City of Portland, Maine – Building or Use Permit Application 389 Congress Street, 04101, Tel: (207) 874-8703, FAX: 874-8716

DATE: 13 July 2009 ADDRESS: 46 Labe/Ave. CBL: 307-A-011

REASON FOR PERMIT: To Construct a 14'x16' deck

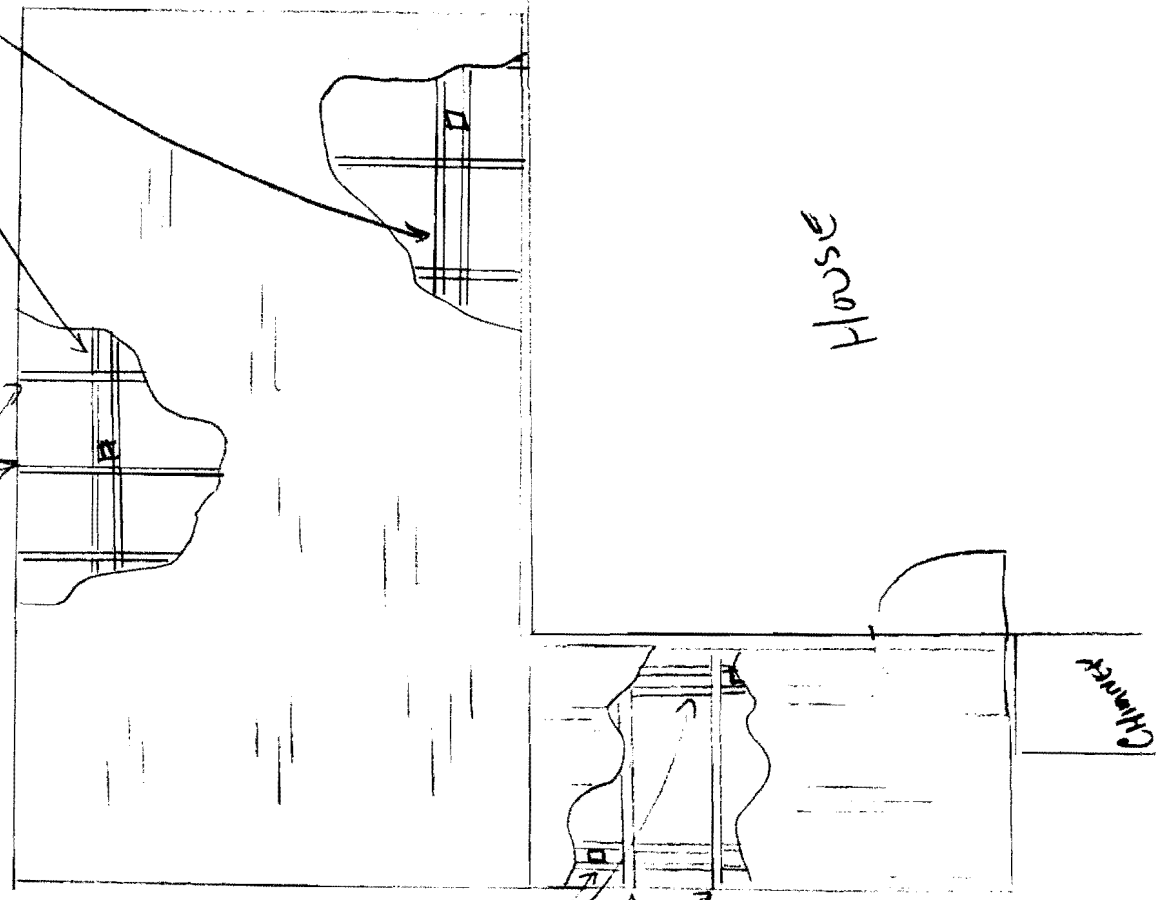
MAX span for
2x8 @ 16" O.C.
is 12' 3"

REAR: 25' req - 40' shown from steps
SIDE: 8' req - 32' shown in 24' shown
FRONT: 25' req - APPEARS THAT THERE IS
24 FT PROJECT TO LINE more than 25'
